**Anchor QEA Technical Memorandum: Engineering Peer Review 60%  
Submittal**

**Re: Port of Poulsbo Breakwater Replacement  
Engineering Peer Review  
60% Submittal**

# PORT OF POULSBO POULSBO, WASHINGTON BREAKWATER REPLACEMENT

60% BREAKWATER DESIGN DRAWINGS

**PORT OF POULSBO  
BREAKWATER REPLACEMENT**  
PILE LAYOUT - PLAN

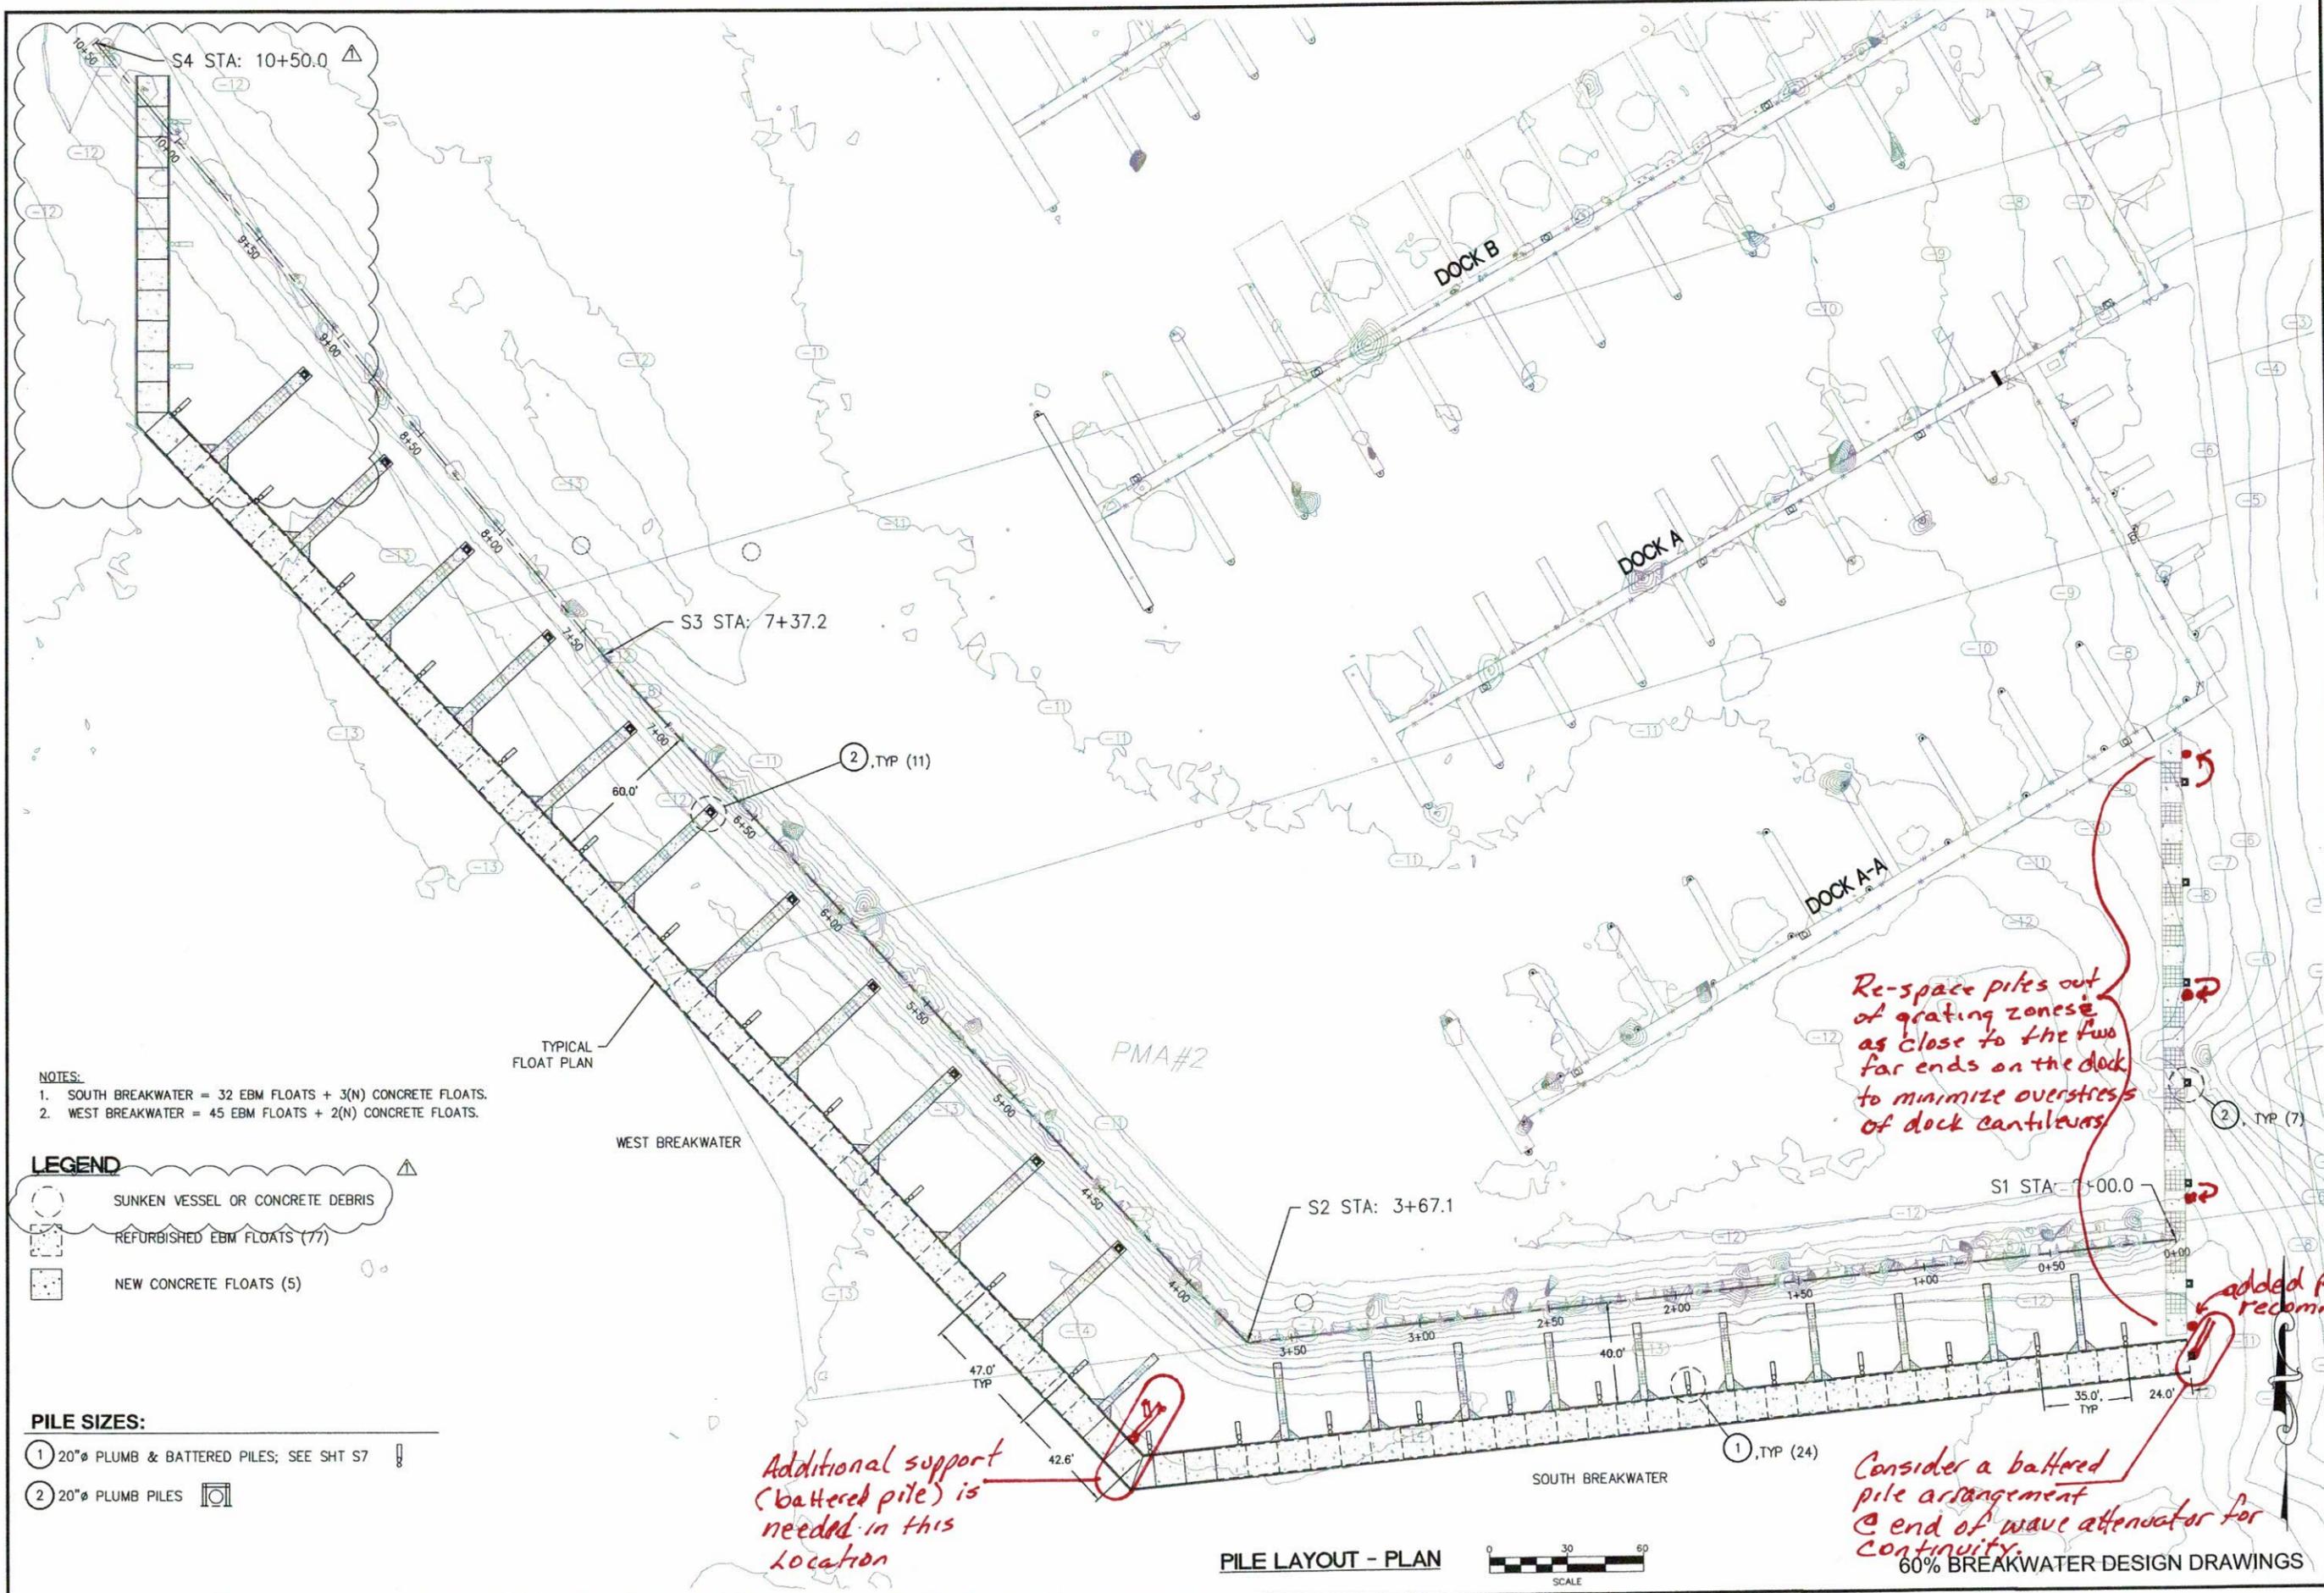
9. S1 – Pile Plan
  - a. Some shifting of guide piles is recommended to reduce stress on the floating pontoons.
  - b. An additional battered pile arrangement is recommended at the knuckle of the wave attenuator.

- c. We recommend a battered pile arrangement at the far east end of the wave attenuator.
10. S2 – Structural Notes

*Re-space piles out of grating zones as close to the two far ends on the dock to minimize overstresses of dock cantilevers.*

*Additional support (battered pile) is needed in this location*

*Consider a battered pile arrangement @ end of wave attenuator for continuity.*

*added pile recommended.*

**SECTION A**  
SCALE: 3/4" = 1'-1/2"

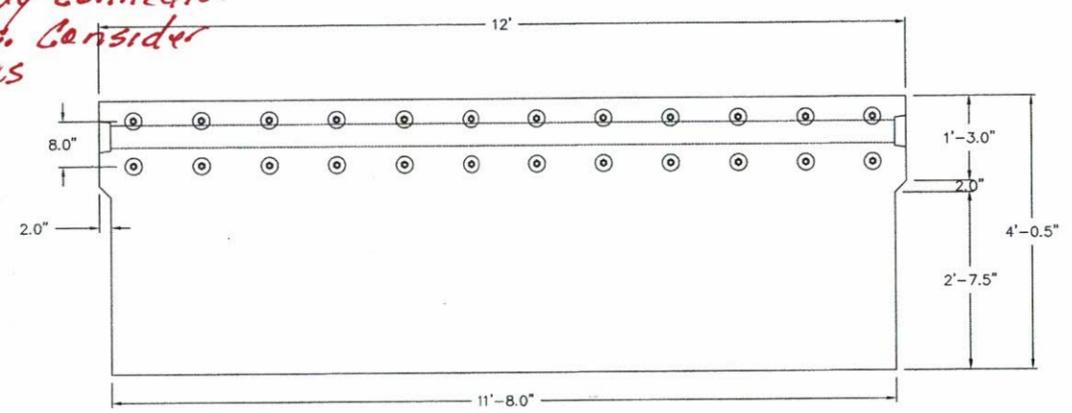
*Pile guide base ps should be designed to utilize attenuator thru-bolts. This is a heavy connection with the tendency to sag. Consider bracing as well.*

**SECTION B**  
SCALE: 3/4" = 1'-1/2"

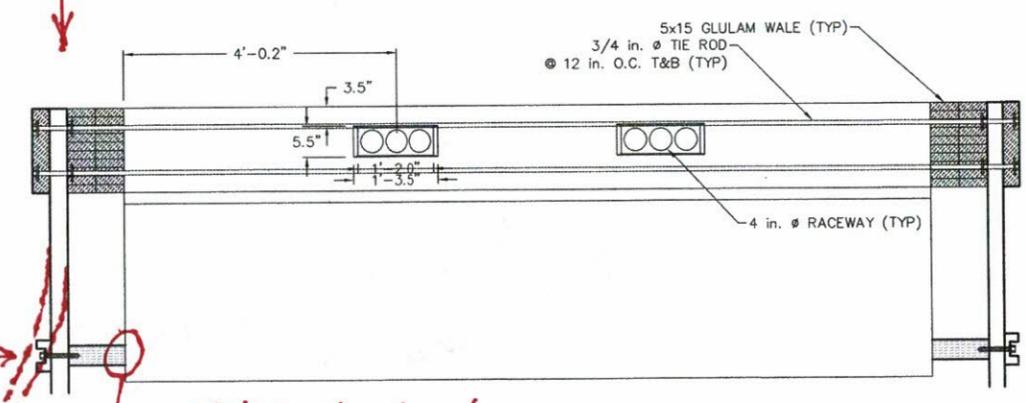
*Wave fence details will cause timber fatigue over time.*

*lag bolts will not survive long.*

*Note: No physical connection, just bearing. Thru bolts to opposite side of float would have been preferable.*

PORT OF POULSBO  
 BREAKWATER REPLACEMENT  
 DETAILS 4 OF 5

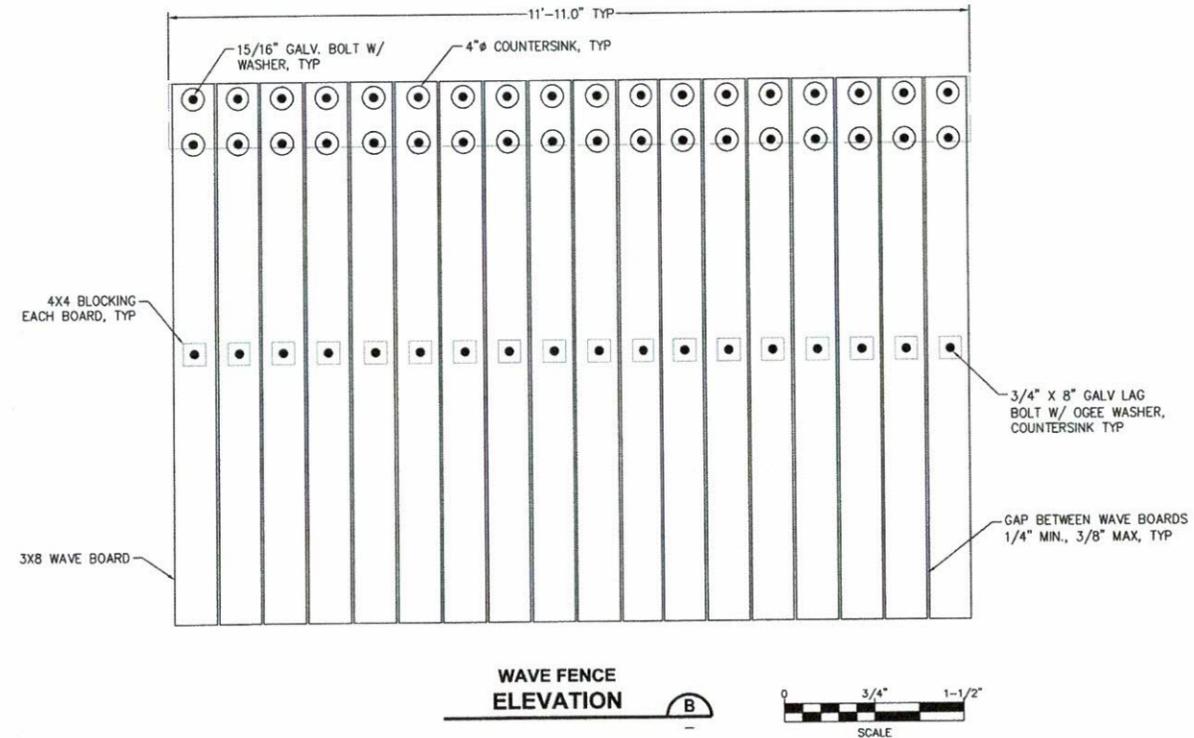
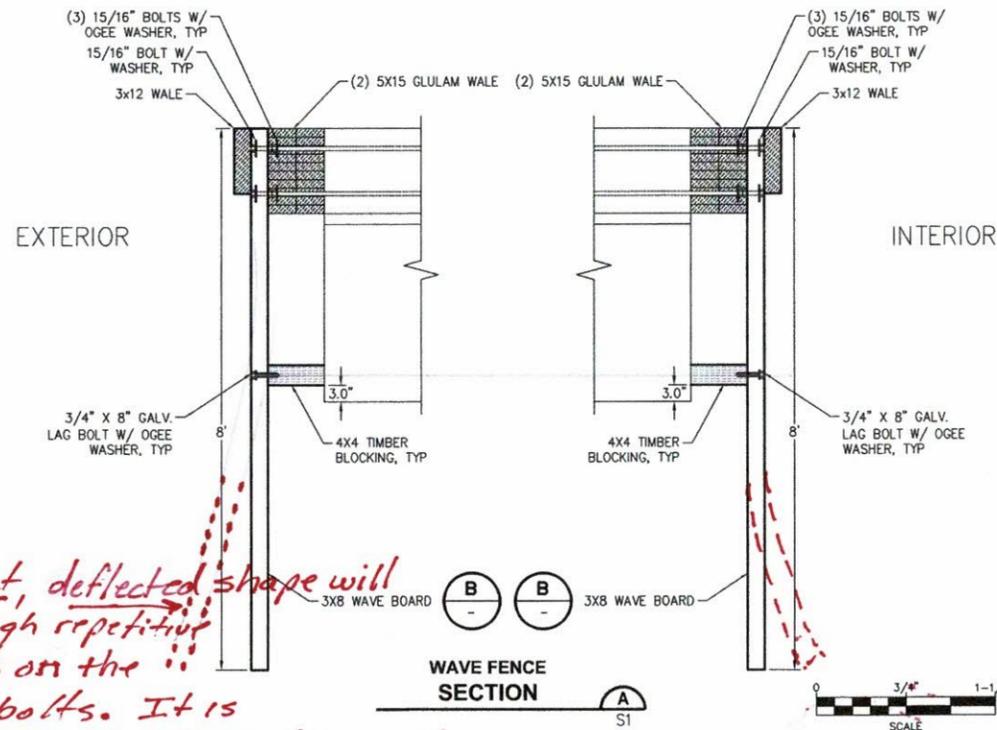
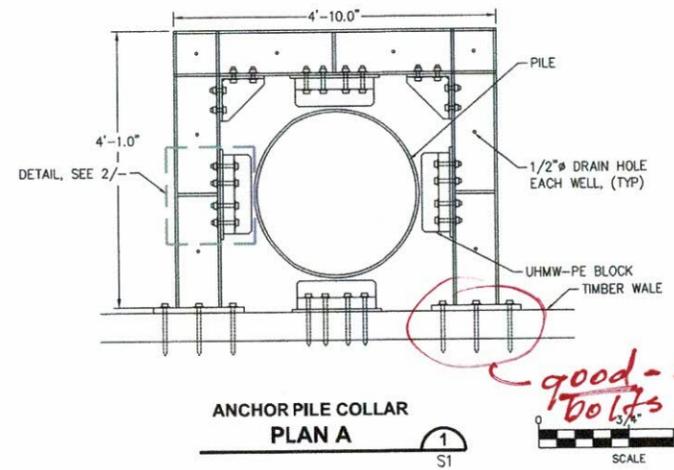
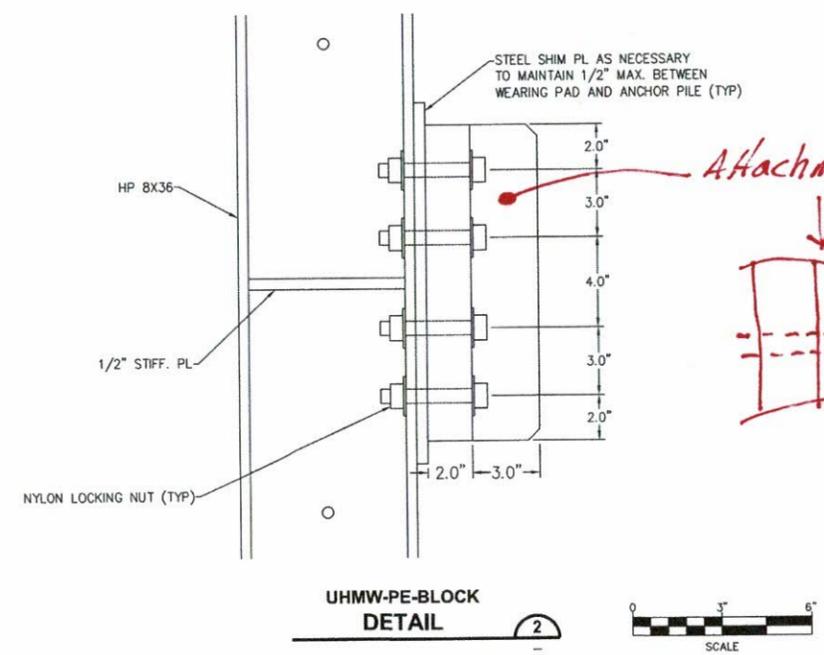
13. S5 – Attenuator Details
- a. Same comment as S3 – Wave Fence Details.
14. S6 – Guide Roller Detail
- a. Drawings do not indicate how the two layers of ultra-high molecular weight (UHMW) material attach. Consider a one-piece UHMW or polyethylene rub block in lieu of a two-piece composite for ease of construction and longevity, or the sketch provided with bolts countersunk.

- b. It is suggested to vertically brace this guide roller to the concrete float, as the assembly will be heavy and will begin to sag over time if not additionally supported.

*Correct, deflected shape will put high repetitive stress on the lag bolts. It is doubtful this type of connection will survive long in these wave conditions.*

*good - Are these the thru bolts supporting to waver fence?*

*Vertical bracing to support the weight of the guide fabrication should be considered.*

*Attachment?*

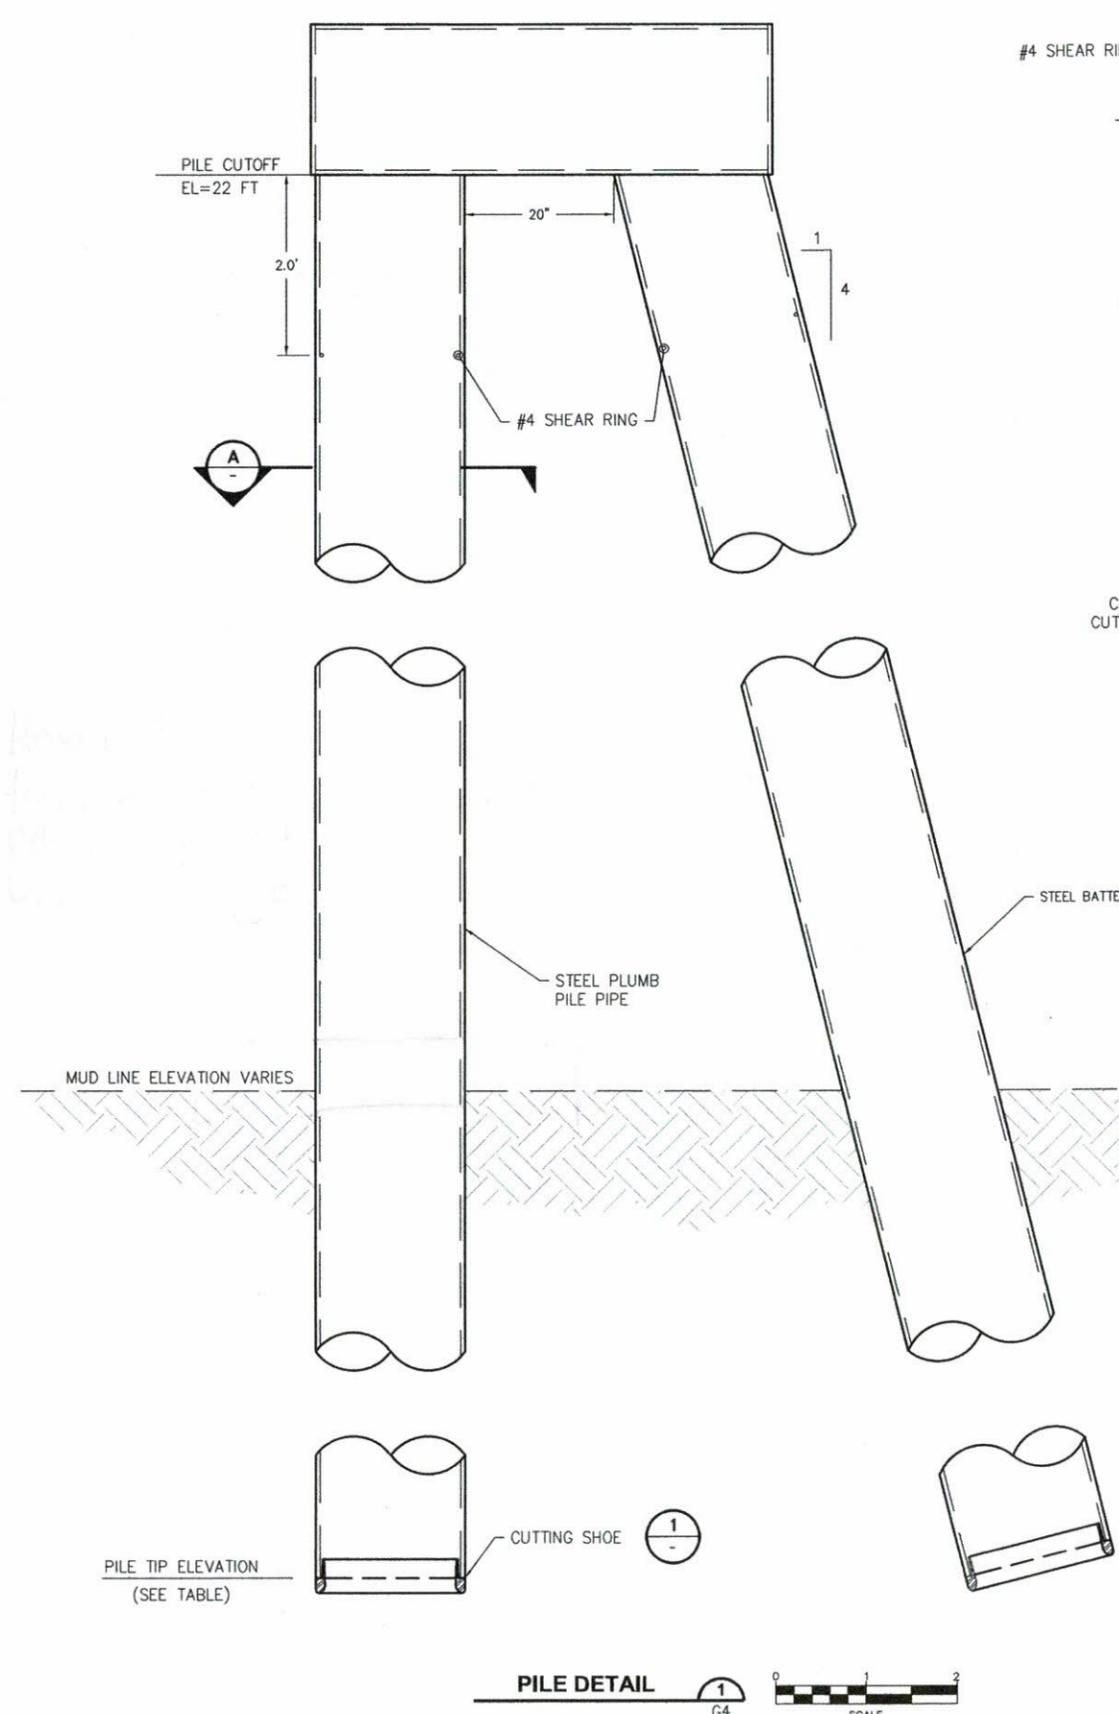
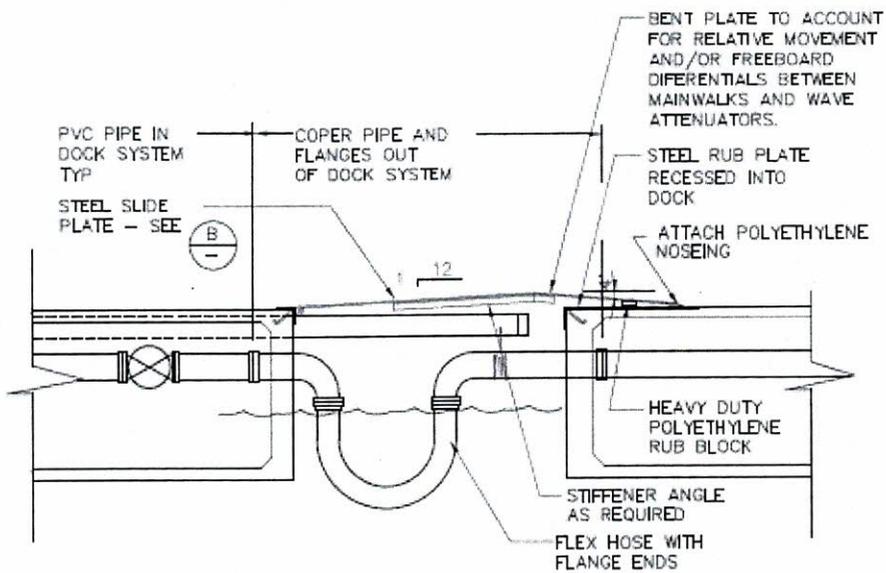
15. S7 – Guide Piles
- a. Is it planned to provide fendering material between the steel piles and berthed boats?

- b. Is the concrete fill within the steel piles needed for structural stiffness? If so, then it is fine. If not, it will not provide much, if any, corrosion protection value and probably should be removed.

*(1) I question the benefit of filling these piles with concrete. Steel pile is totally sealed once cap is welded and will not corrode-inside-out*

*Is there any intent to cushion these piles to prevent boat damage? Floating fender tubes are available.*

*(1) There have been studies to determine the effectiveness of filling pipe piles with concrete to mitigate corrosion. Studies have concluded it doesn't help much. But if it is needed for pile strength, it does increase the stiffness of the pile and has benefit.*
